Improved safety for cylindrical GUPM

New locking protective cover 1025

Value: Maintenance, Safety&Ergonomy
Equipment: Blower S2 and Universal
Catalogue code: 1025

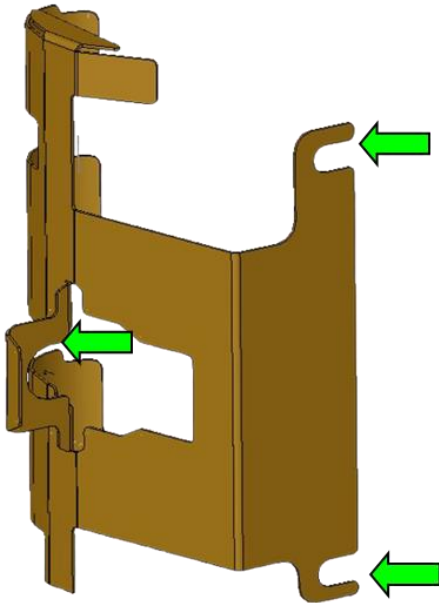
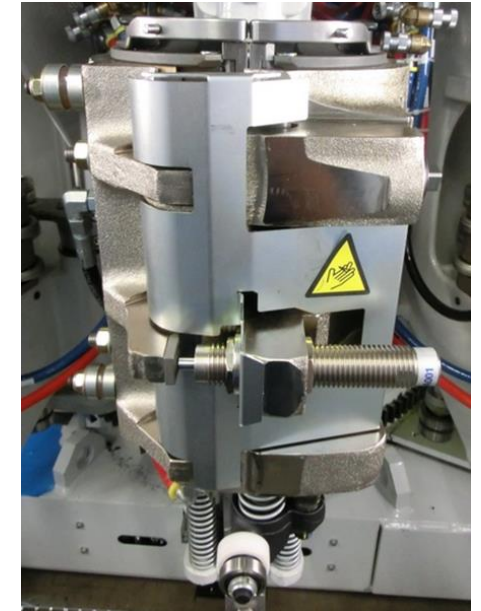
- The unit of the cylindrical mold carrier and Universal Series 2, comprises a casing which protects the operator during closing of the lock.
- At the end of its life, the protective casing may break at the only attachment point located on the damper of the mould-holder unit.
- Through this improvement we to increase the robustness of the housing, and indirectly, to improve the security level.

- Quick and easy to assemble.
Using two threads existing M12 located right on the square.
- Shape similar to the current case.
With housing in place, it is permanent protection for the operators.
